Value Engineering Study

Final Report

Kentucky Transportation Cabinet I-71 Widening, MP 14.1 to MP 18.0 Oldham County

Item No. 5-483.10

VALUE ENGINEERING PROPOSAL NO. 1

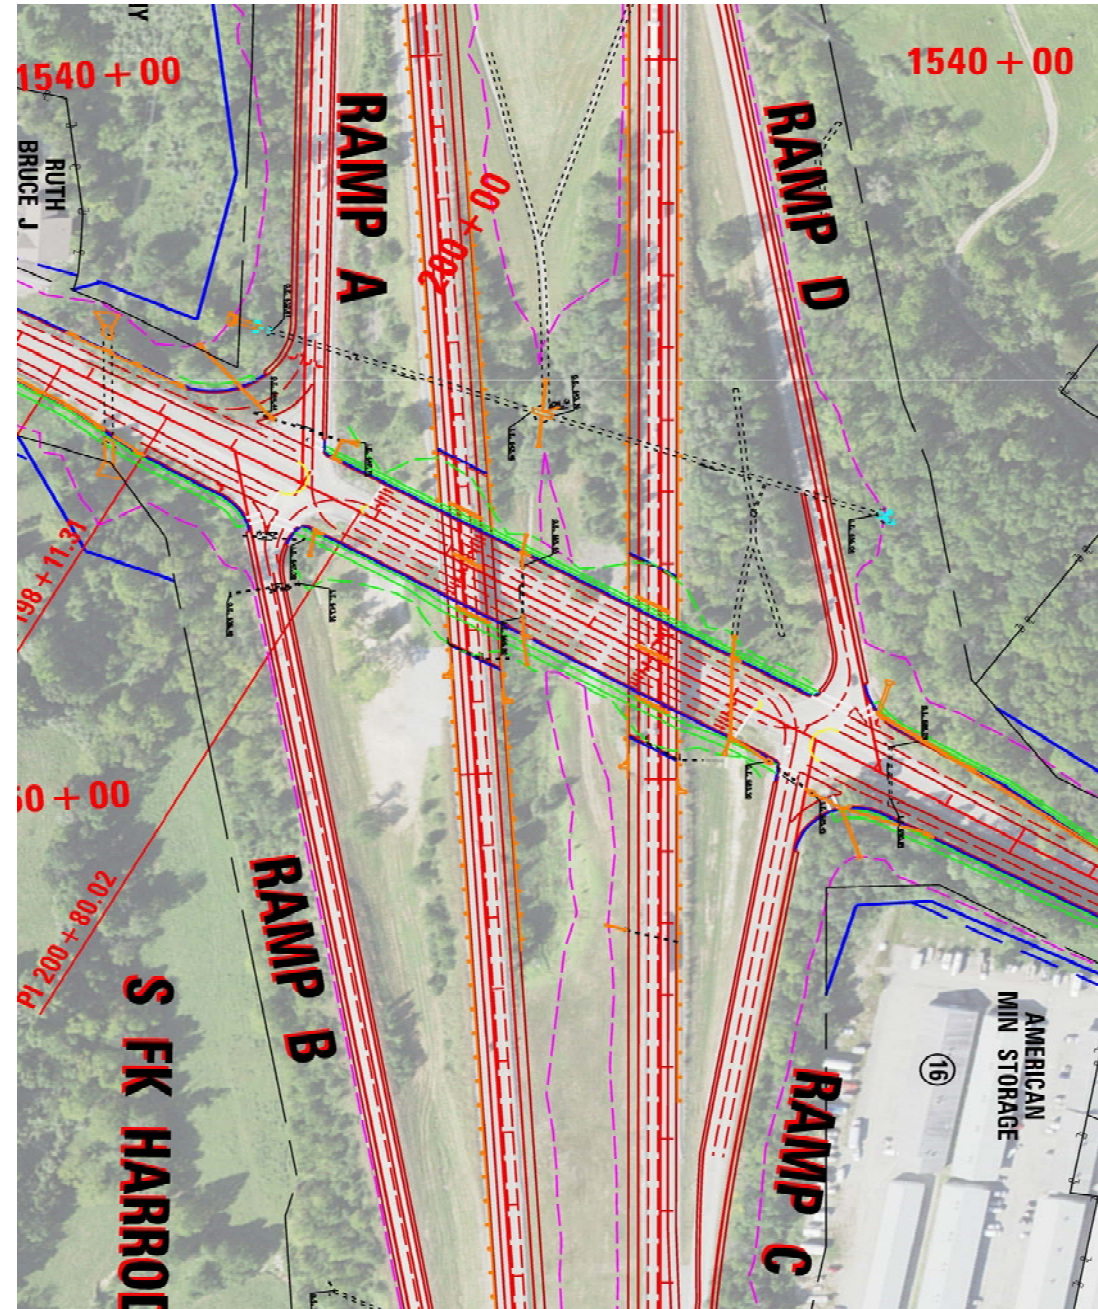
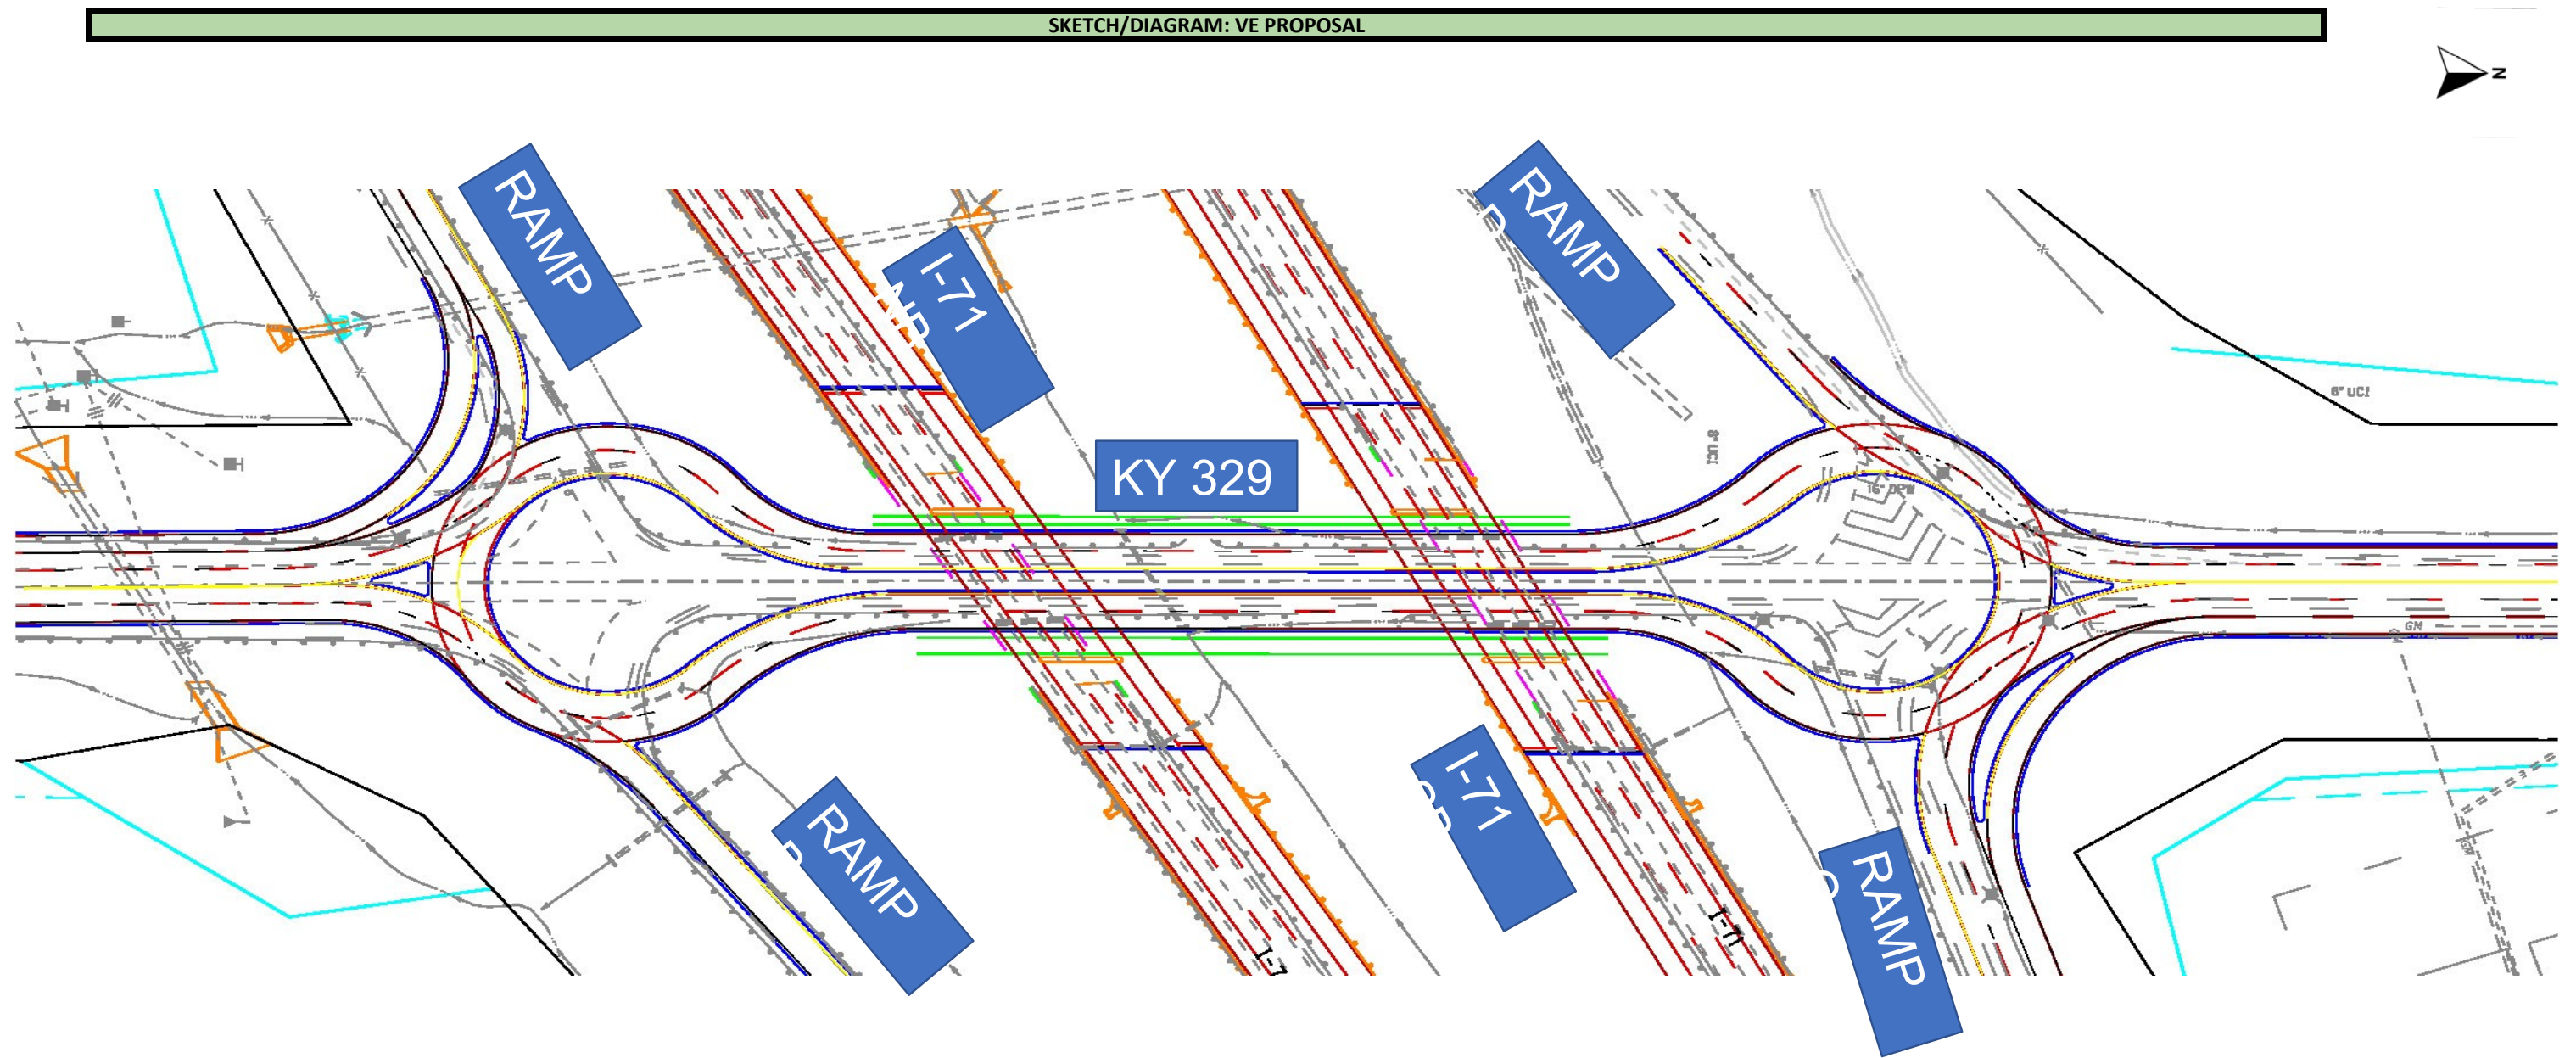
TITLE	Redesign the KY 329 Interchange		
FUNCTION	Enhance Connectivity		
VE PROPOSAL SYNOPSIS:			
Constructing a "dogbone" interchange at KY 329 will reduce intersection delays at the ramp terminals while also improving safety performance in particular from a fatal and serious injury perspective. This will also decrease the total amount of asphalt pavement to be constructed and maintained long-term.			
 Reliability	Improved	 Functionality	Improved
 O&M	Improved	 Schedule Impact	Maintained
			\$ Initial Cost Avoidance (Add)
			\$2,693,000
BASELINE CONCEPT DESCRIPTION:			
KY 329 has two lanes in each direction with multiple turn lanes at the I-71 ramp terminals. Traffic signals will be constructed at the ramp terminals.			
VE PROPOSAL DESCRIPTION:			
Construct a "dogbone" interchange (with roundabouts at the ramp terminals). This would still maintain two lanes of traffic in each direction.			
VE PROPOSAL ADVANTAGES:		VE PROPOSAL DISADVANTAGES:

TITLE	Redesign the KY 329 Interchange
DISCUSSION & JUSTIFICATION:	
<p>Considering the impending development immediately adjacent to the KY 329 interchange, the value team proposes reconsideration of the Diverging Diamond Interchange (DDI) as well as investigating the feasibility of constructing a “dogbone” interchange (with roundabouts at the ramp terminals). Both options provide a narrower footprint for KY 329 with the DDI carrying 3 lanes of traffic in each direction under the bridges and the dogbone alternate carrying two lanes of traffic in each direction under the bridges. This propagates beyond the ramp terminals as well as lanes are added and dropped approaching the terminals.</p>	
<p>Based on our initial study, the value team proposes to construct a dogbone interchange. This alternate will allow the design team to reduce the typical section through the interchange from 8 total lanes (2 in each direction with a dual left headed north on KY 329 and a single left headed south on KY 329 as well as excess pavement for a center pier for the I-71 overpass) to 4 total lanes of pavement plus a raised median to separate the two directions of traffic. This will reduce the initial construction cost as well as the long-term maintenance costs on KY 329 by requiring less pavement, although you would have the additional cost of the raised median.</p>

It should be noted that any cost avoidance/add with this proposal does not consider possible reduction of the I-71 mainline bridges. These could be reduced by approximately 25% due to the reduced roadway width over which they must span.

The value team recommends the design team run further traffic simulation on the dogbone interchange to verify the results of the value team's HCS analysis.

TITLE Build new I-71 bridge over KY 329 with common I-71 median

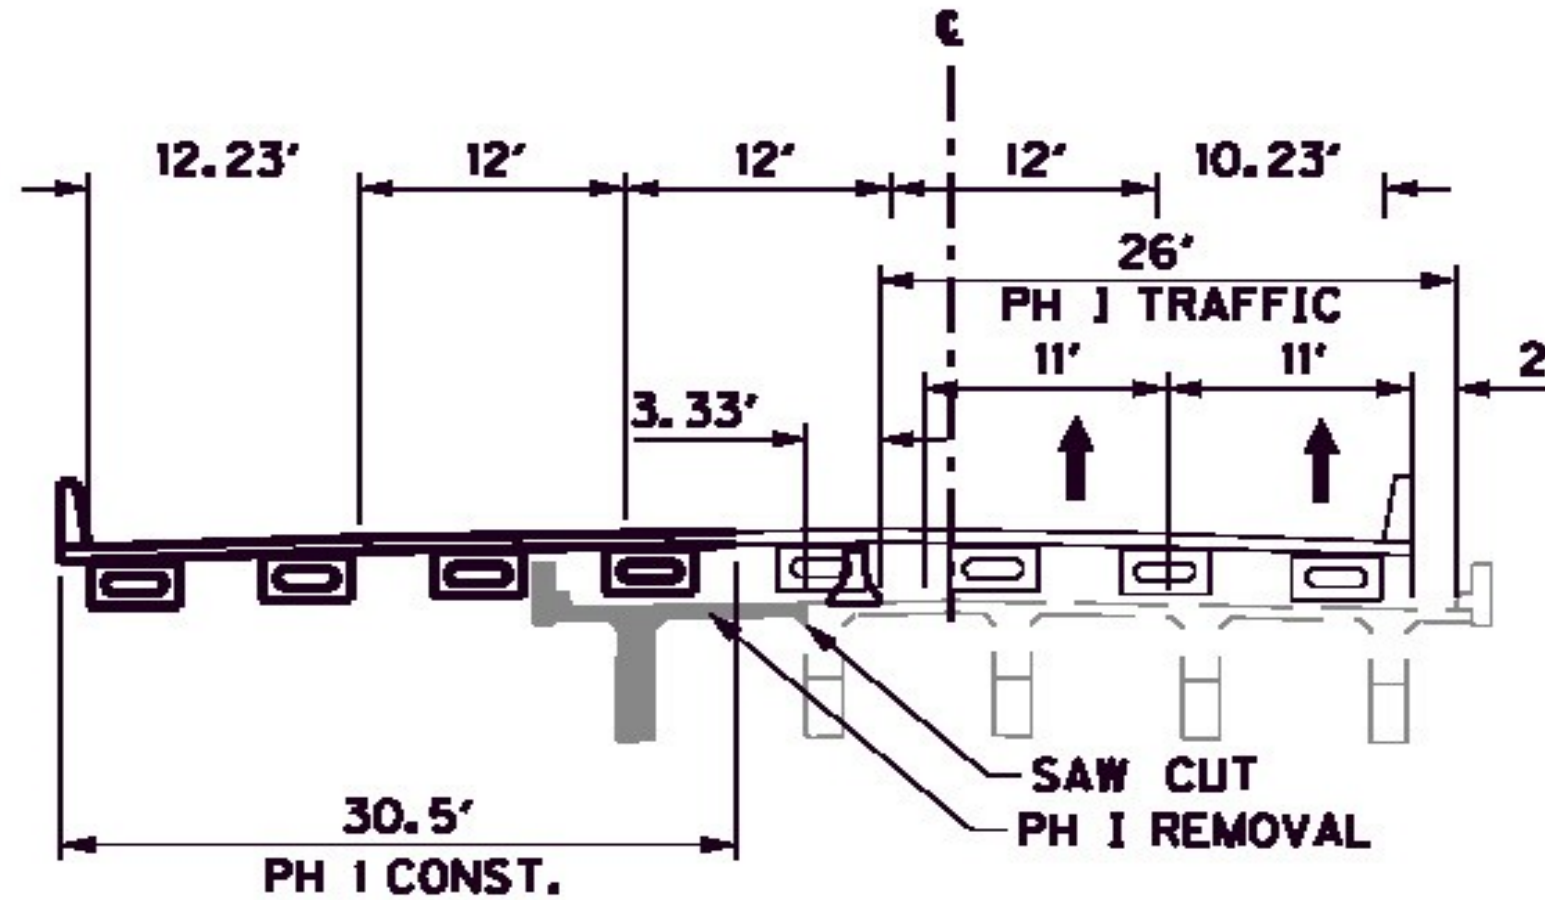
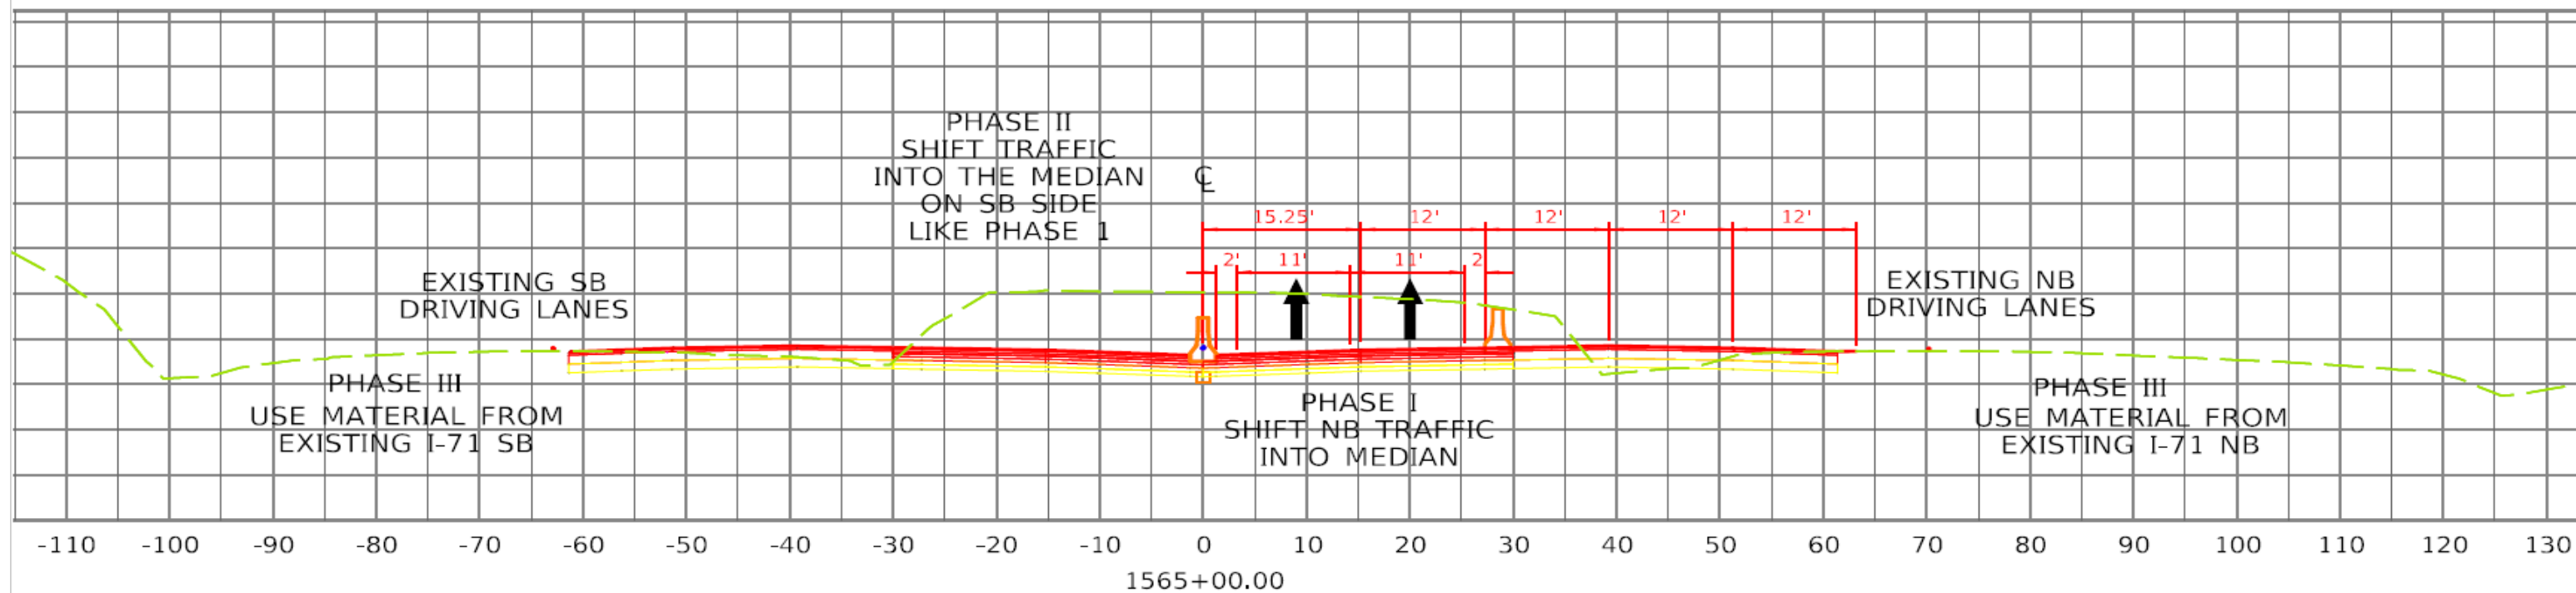
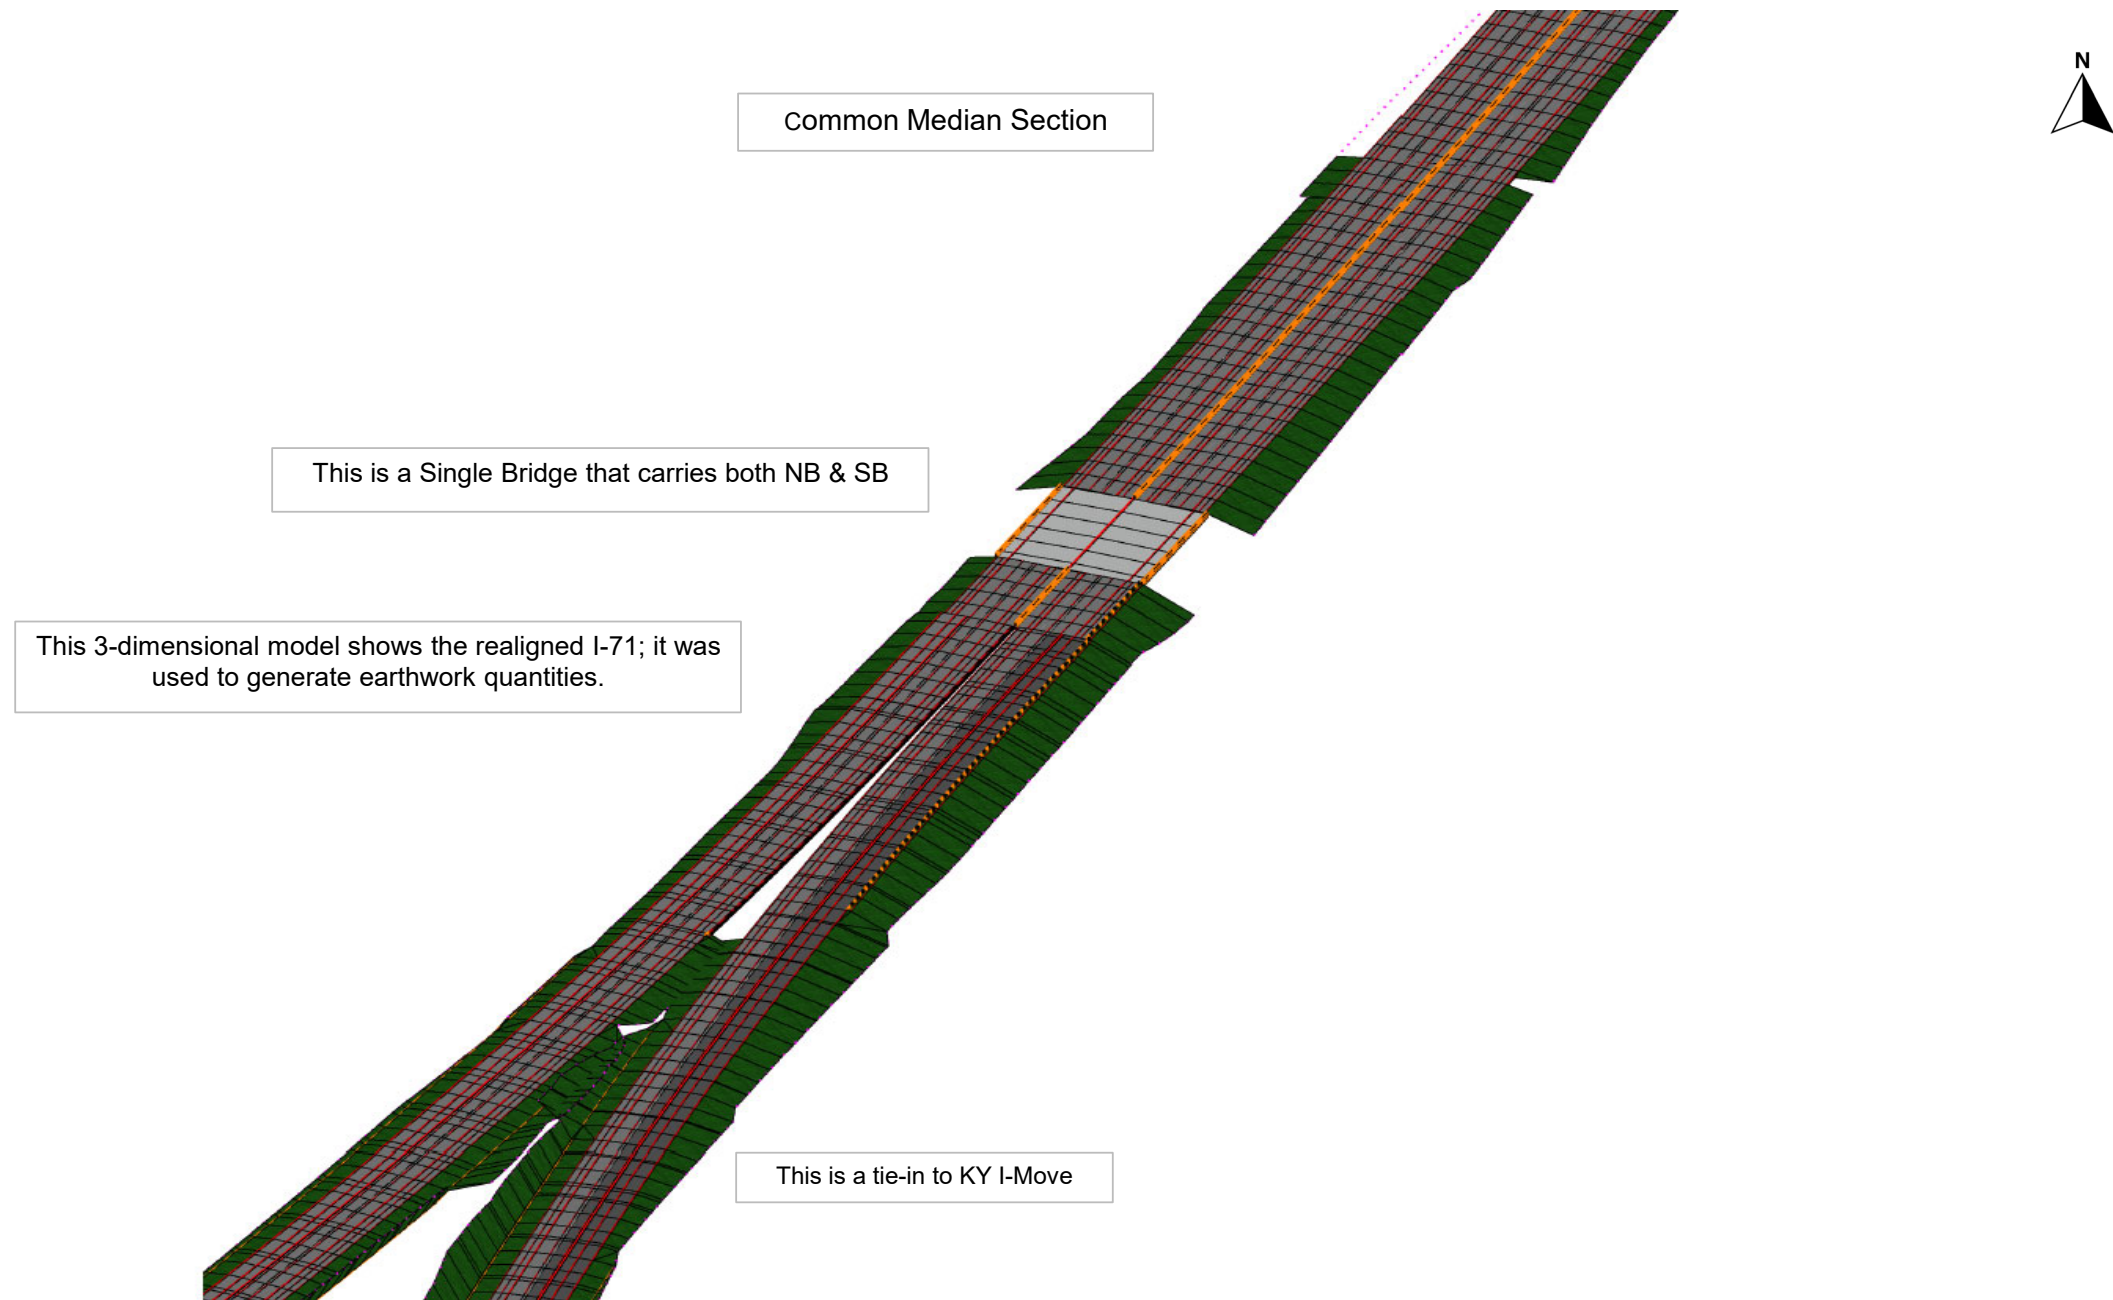
TITLE	Build new I-71 bridge over KY 329 with common I-71 median		
FUNCTION	Enhance Connectivity		
VE PROPOSAL SYNOPSIS:			
Construct a 3-span bridge over KY 329 (no median pier) where the center span will span an 8-lane curb and gutter section with the multi-use path and sidewalk located behind the shoulder piers			
 Reliability	Maintained	 Functionality	Improved
 O&M	Maintained	 Schedule Impact	Improved
			\$ Initial Cost Avoidance (Add) \$397,000
BASELINE CONCEPT DESCRIPTION:			
Bifurcated along existing NB and SB, widened to the inside using part-width bridge construction. Proposed 4-span (60-70-70-60) twin bridges. Each twin bridge is 61-ft wide with 24-ft raised median in KY 329 for median pier.			
VE PROPOSAL DESCRIPTION:			
Shift mainline roadway alignment from the bifurcated section to a common median resulting in a new single 3-span bridge carrying both directions of traffic over KY329.

One offshoot to this concept is that the proposed bridge can also be constructed as twin bridges such that each twin bridge is far enough away from the existing bridge to eliminate shoring. etc. Doing this will allow transitioning back into the I-MOVE section much quicker, thus reducing the length of added roadway to construct to tie back into I-MOVE and the amount of fill required could be greatly reduced.
